## Bid Bulletin # 3 FAMC Tower Bid Package # 3

December 2.2013  
**December 12, 2013**

Fremont Area Medical Center  
Bid Package#3- Interior Fit up

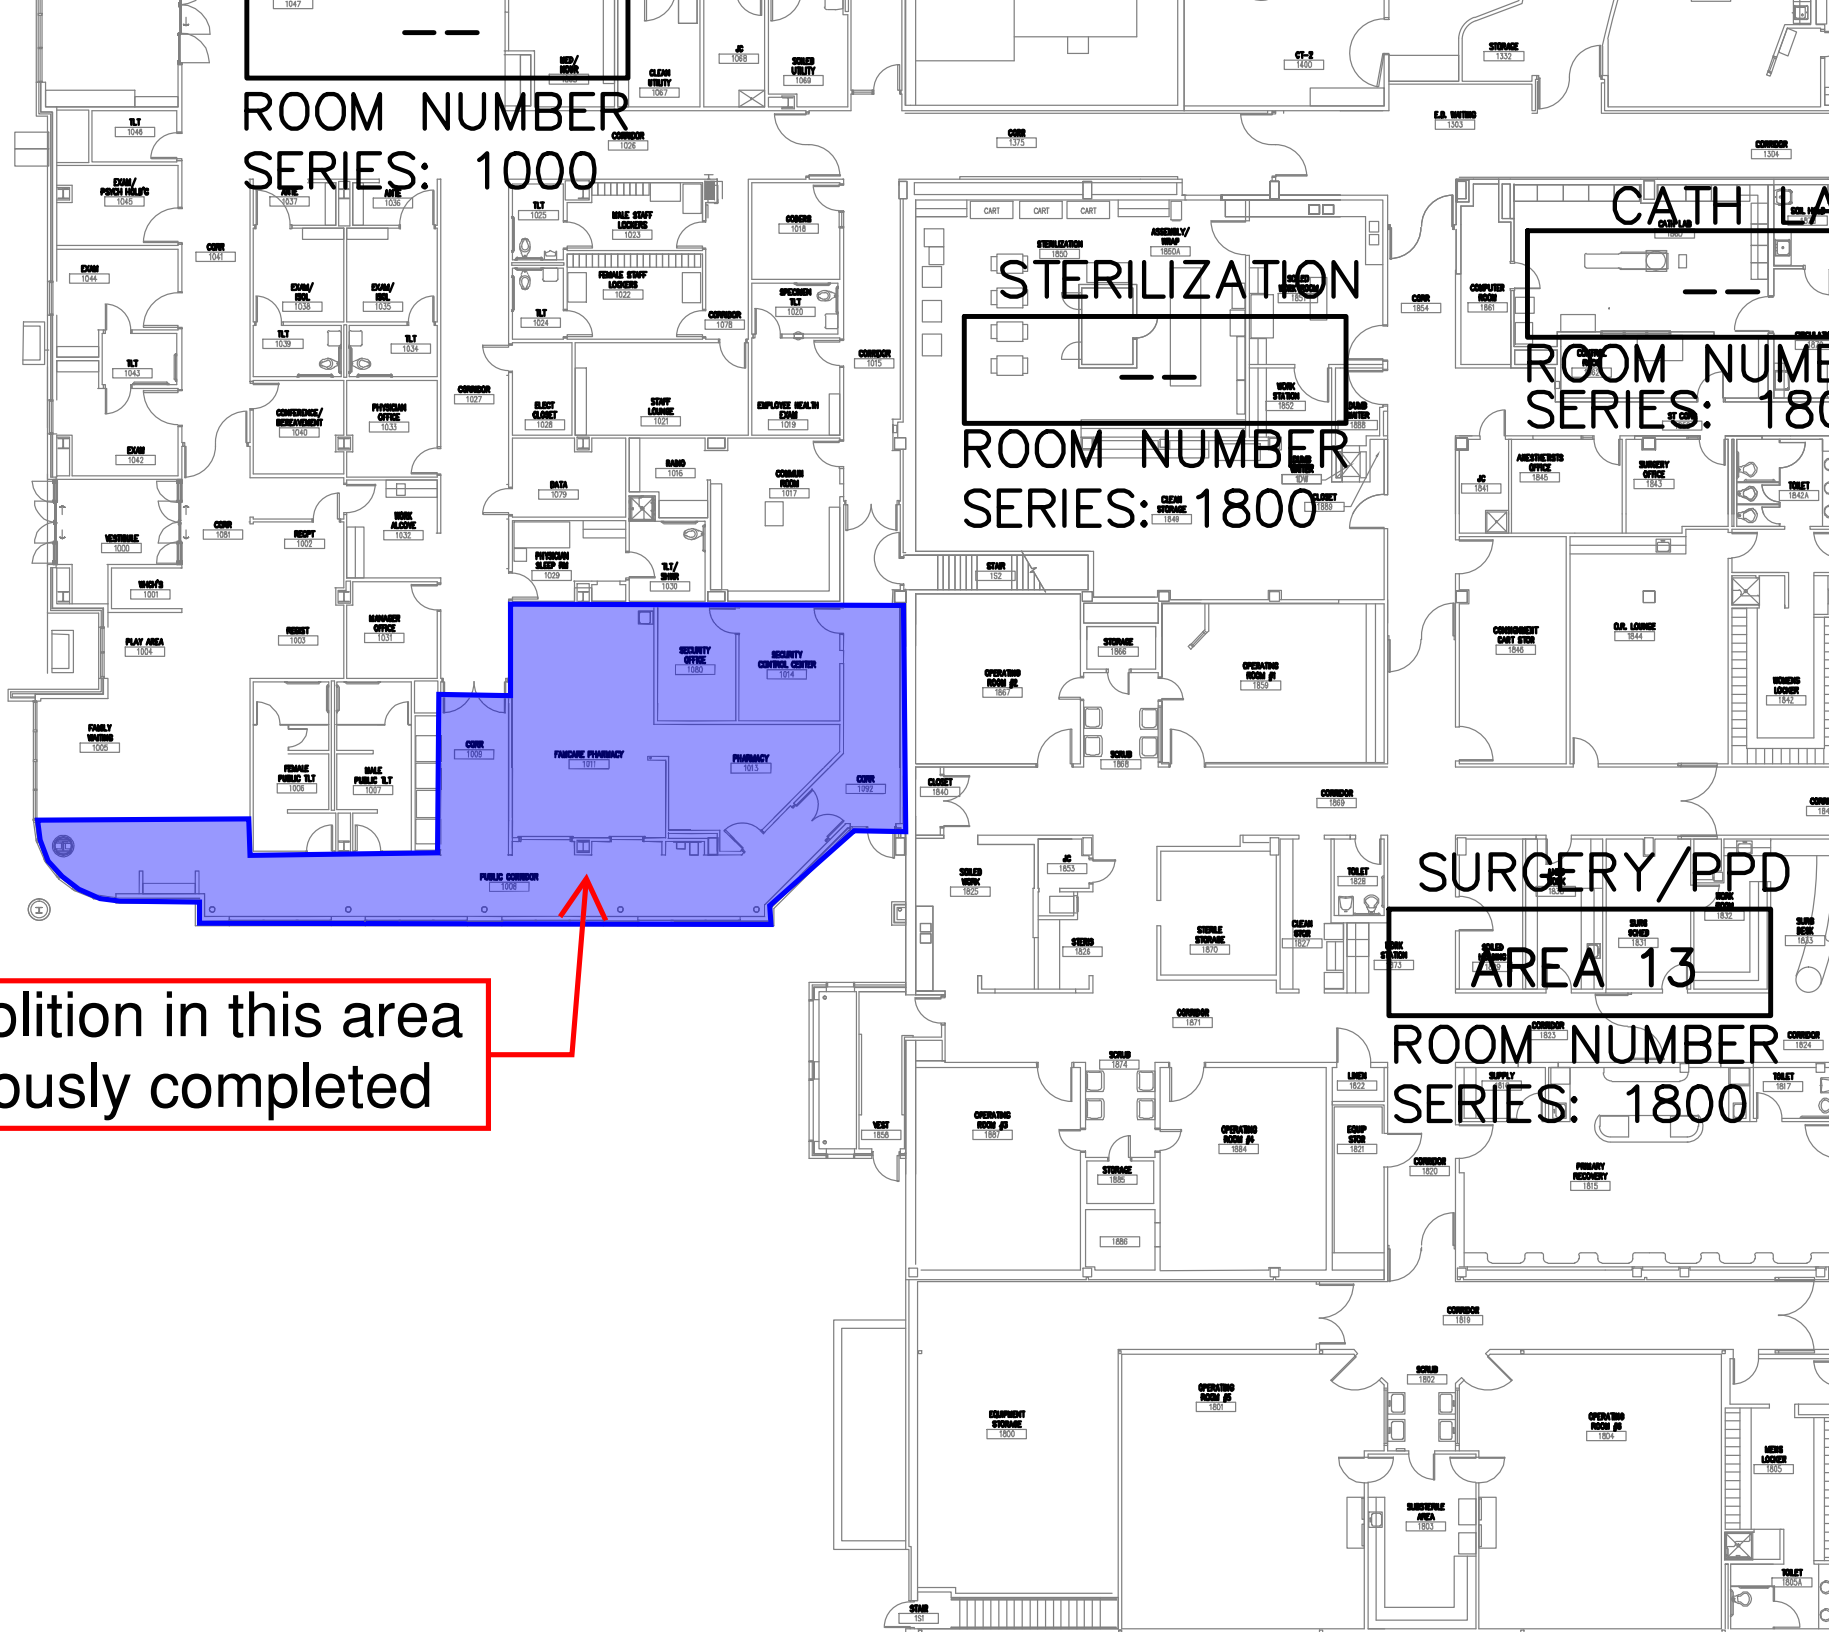
Demolition in this area  
previously completed

THIRD FLOOR

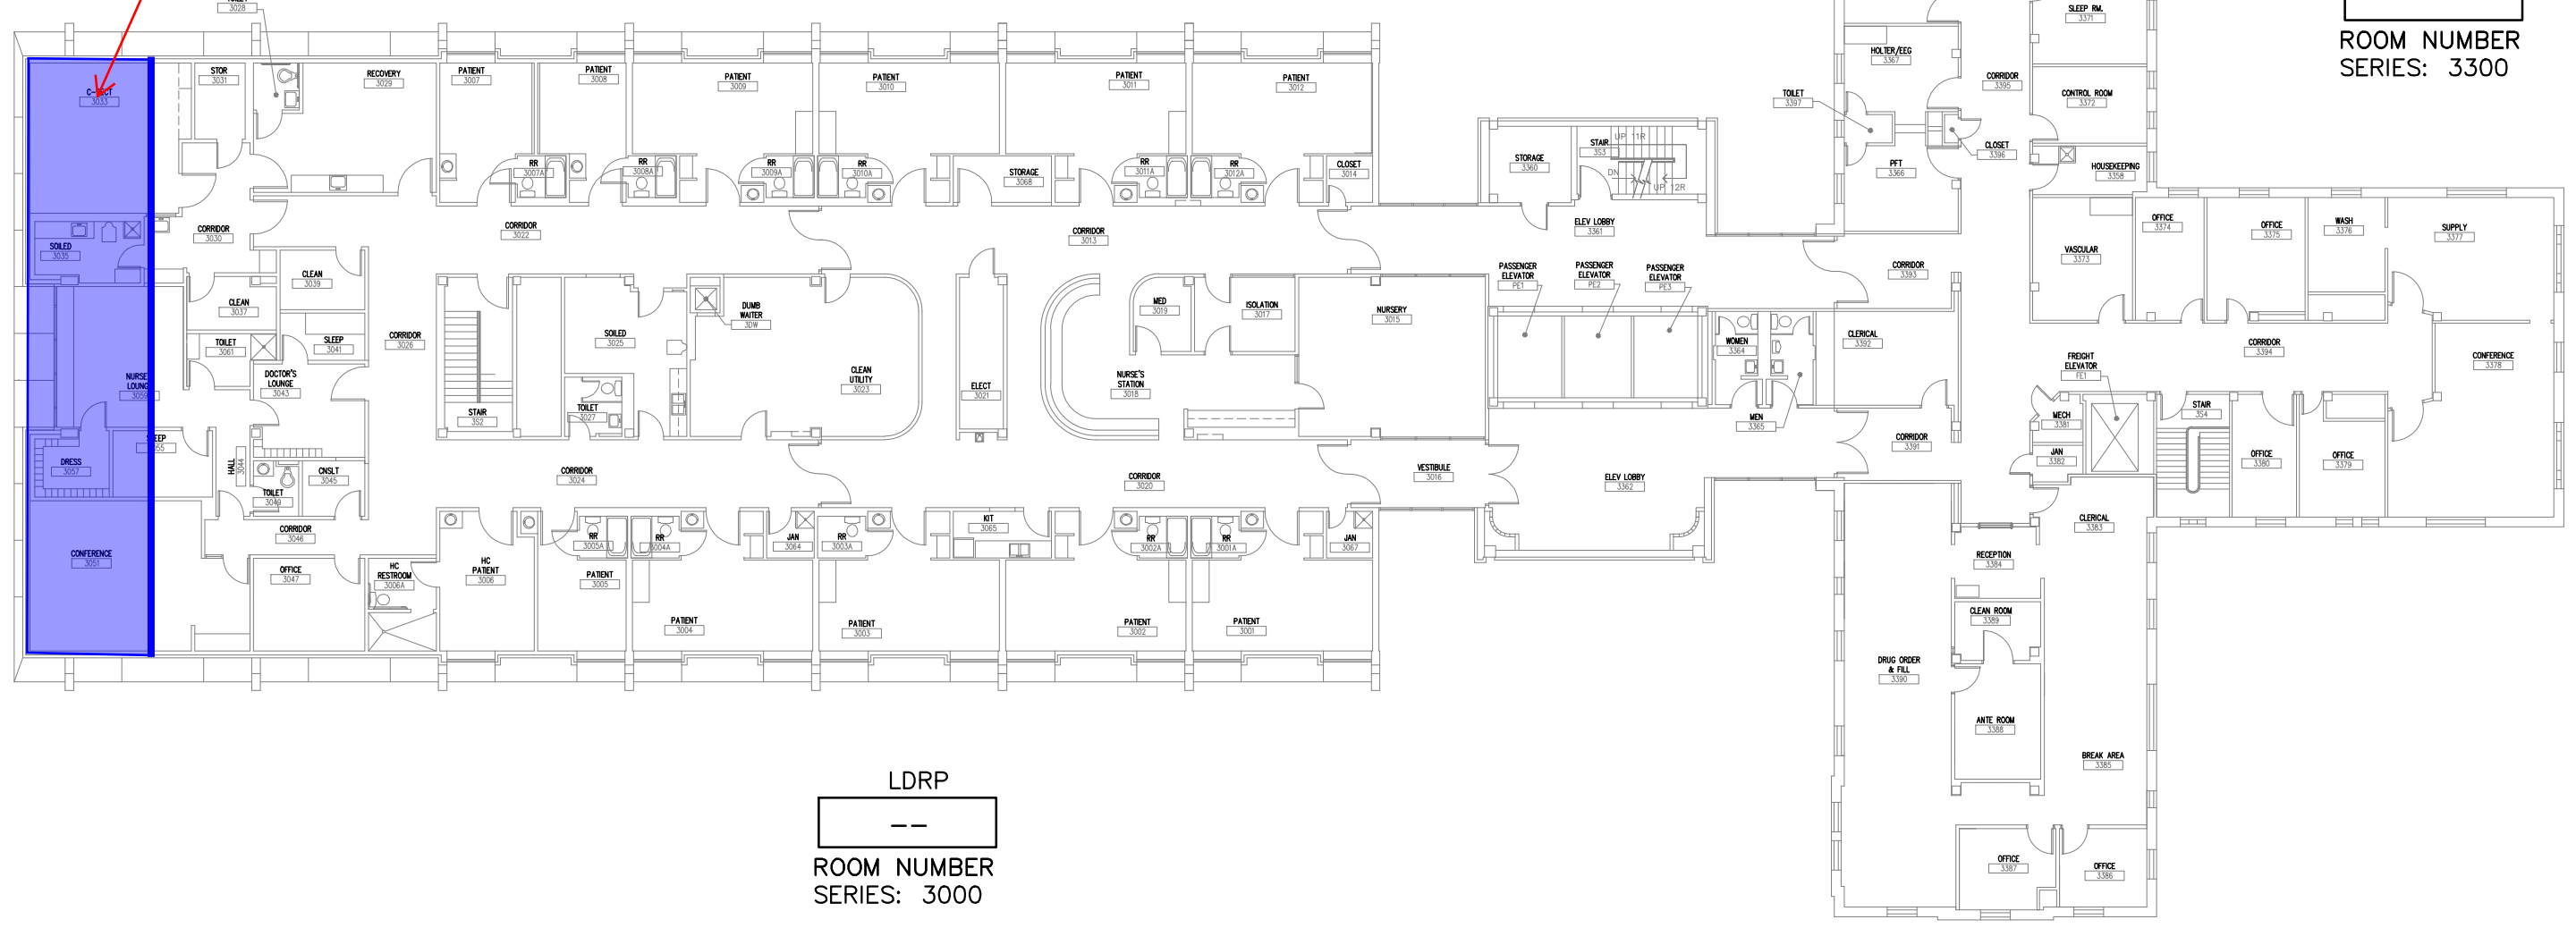
Demolition in this area  
previously completed

FIFTH FLOOR

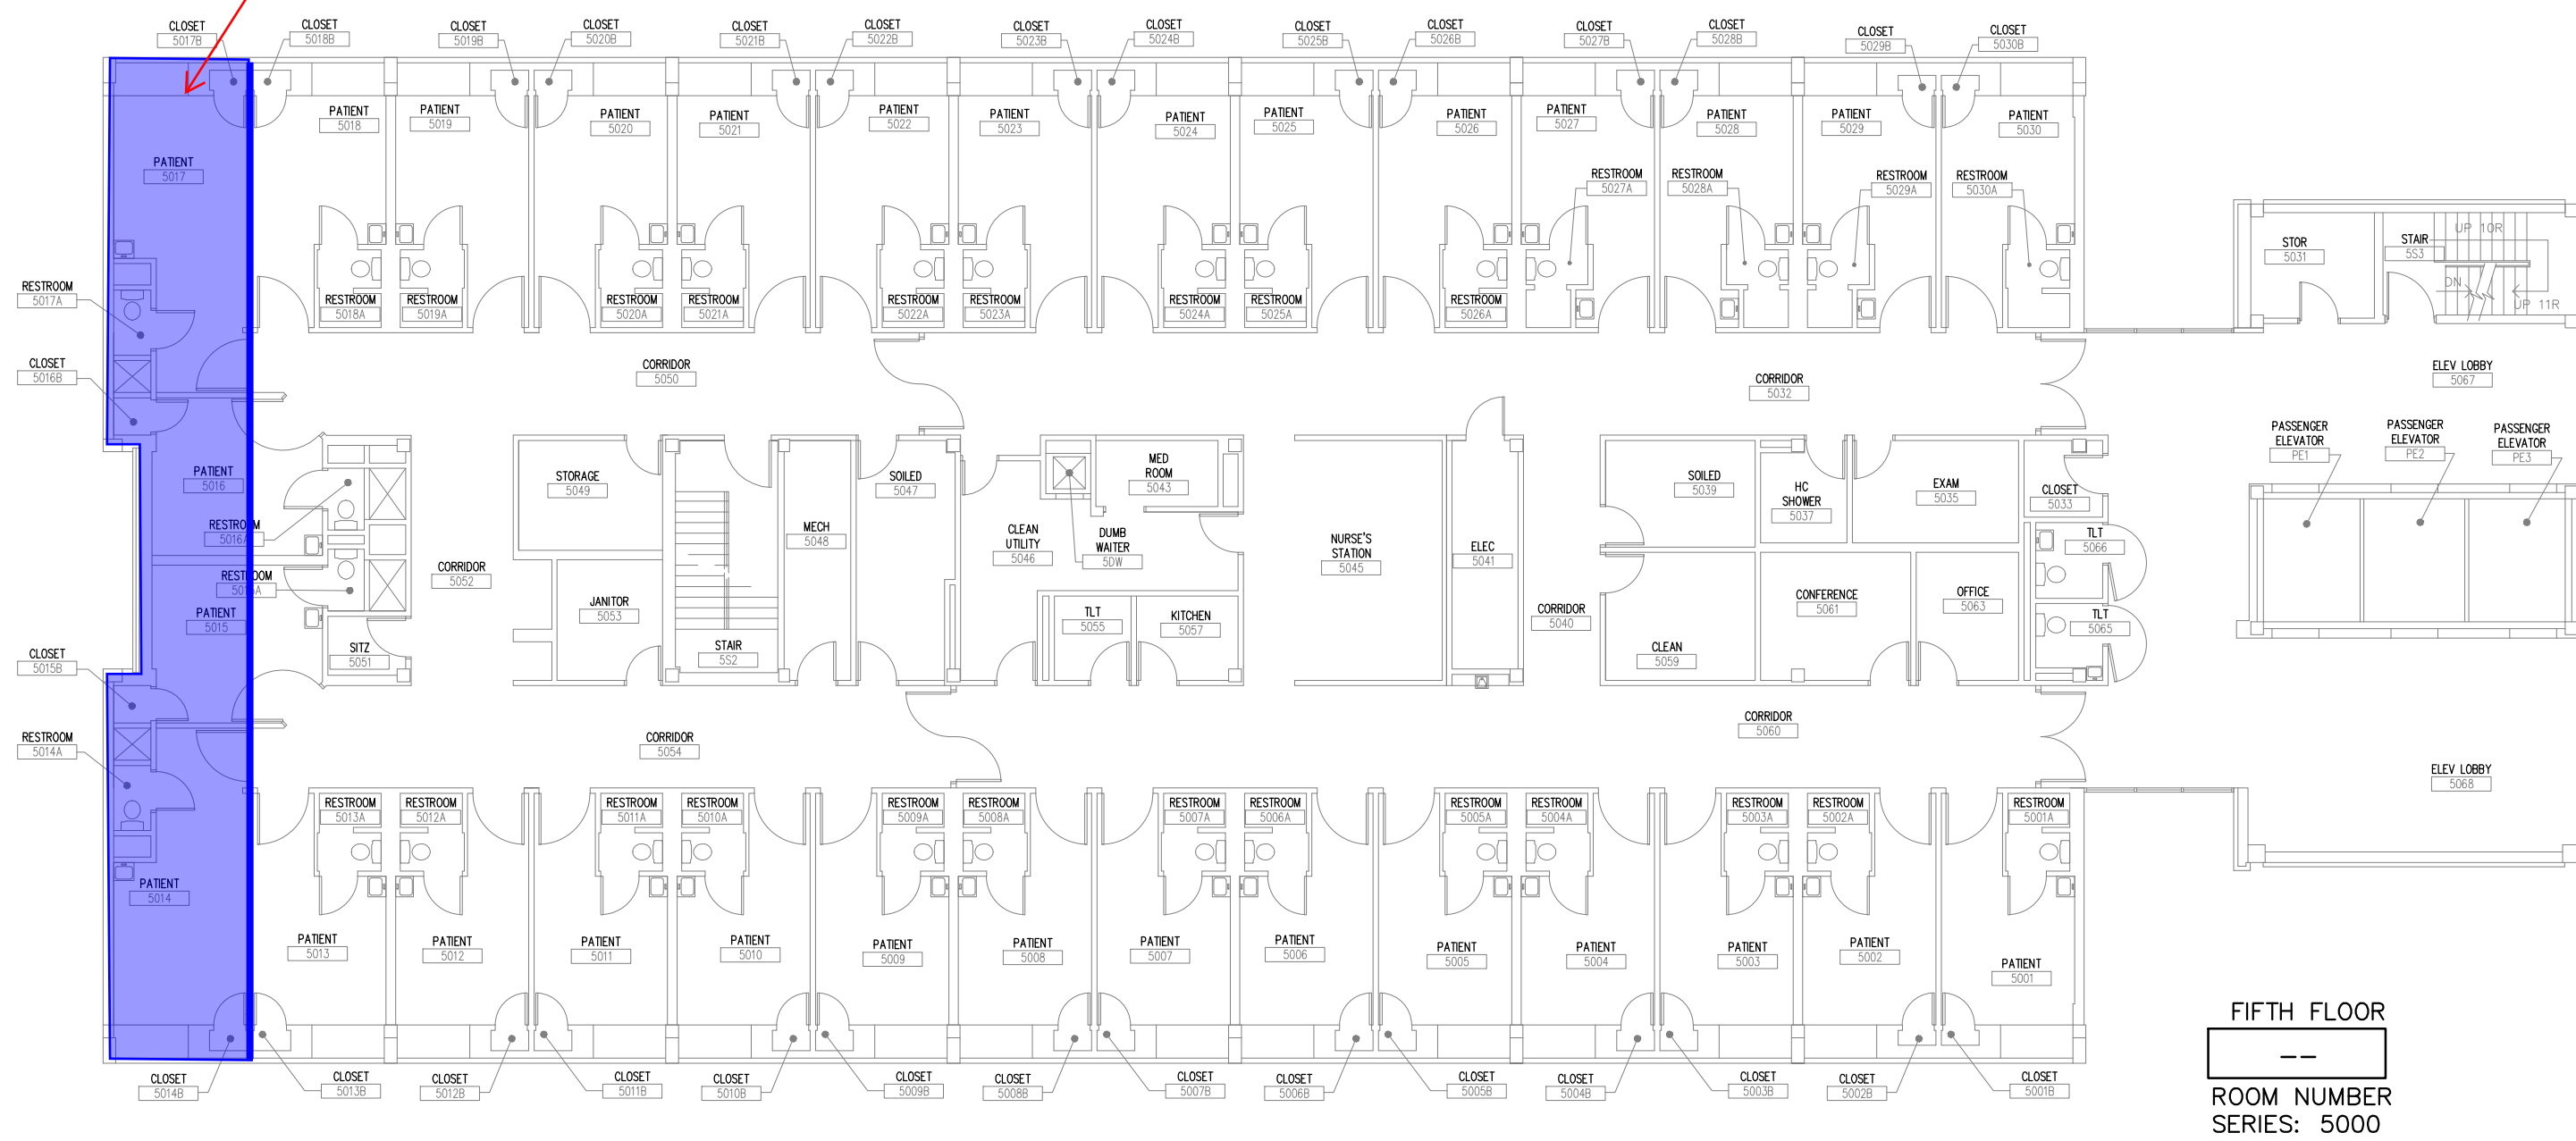
Demolition in this area  
previously completed
